# Proposed Revisions to Block 18 Project Controls Urban Renewal Board Presentation January 26, 2015

#### **Proposed Revisions to Block 18 Project Controls**

(11-5 / 11th St "Entertainment Retail")

DRAFT 9.9.2014 - Prepared by McCann Adams Studio for City of Austin NHCD

Figure 4-9: 11<sup>th</sup> Street Entertainment Retail

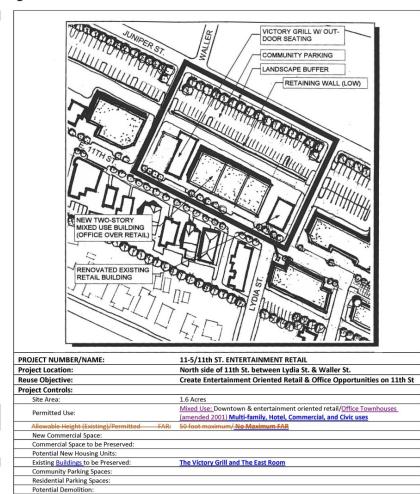
- Resolve Victory Grill boundary, code, and building condition and utility issues.
- Allow for more diversity of principal uses, such as residential, civic and hotel.
- Remove prescriptiveness in terms of certain uses, # parking spaces, max amount of commercial.
- Increase FAR to 2.0, site-wide.
- Increase building cover to 90%, site wide.
- Increase impervious cover to 95%, site wide.
- Reduce Juniper St frontyard setback to 10'.

-EXISTING ZONING SCENARIO - BLOCK 18 1"=30" 1.26.2015" MAS

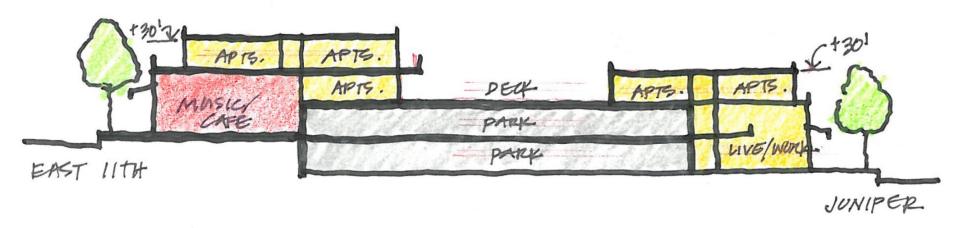
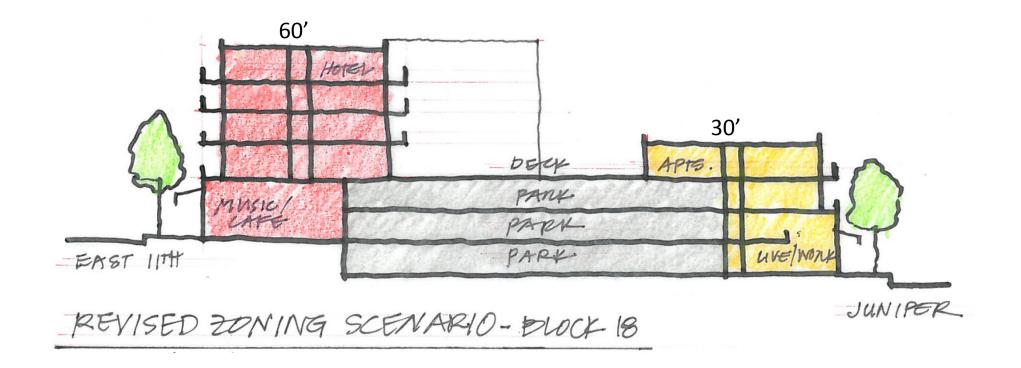
- 0.97 FAR (SUB 1) & 0.75 FAR (SUB 2)
- 90% BLDG COVER (SUB 1) & 60% (SUB 2)
- 95% IMP COVER (SUB 1) & 80% (SUB 2)
- NO SETBACKS (SUB 1)
- 15' FRONT SB; 10' SIDE ST SB; 5' INT SY & REAR SBs (SUB 2)

#### **REVISED ZONING SCENARIO: SITE SECTION LOOKING WEST**

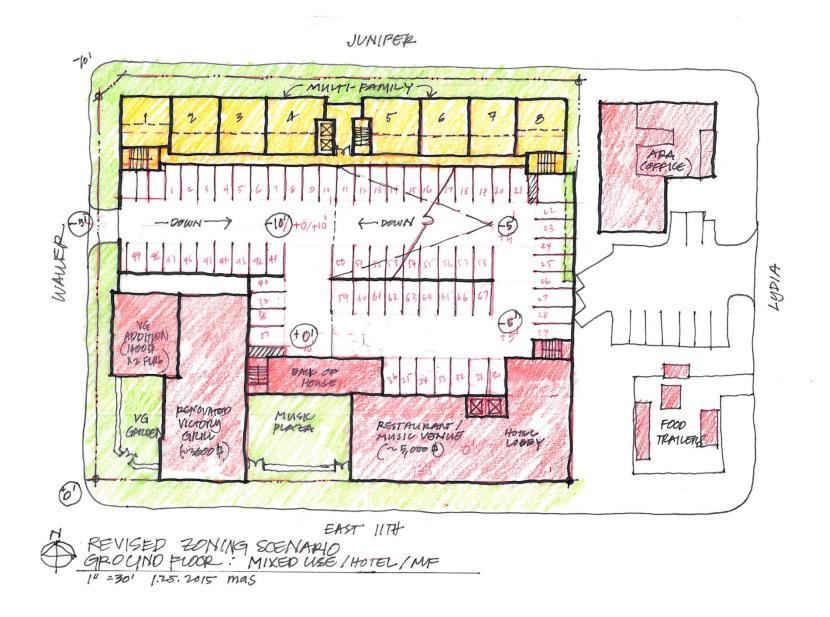
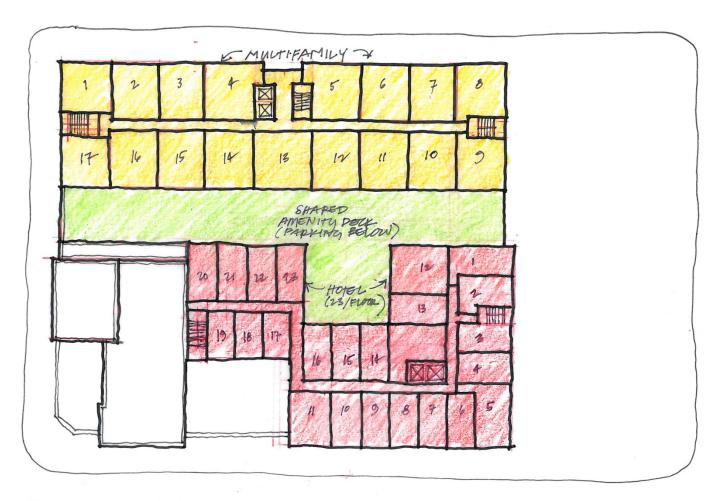
- 2.0 FAR
- 90% BUILDING COVER
- 95% IMPERVIOUS COVER
- 10' JUNIPER ST SETBACK
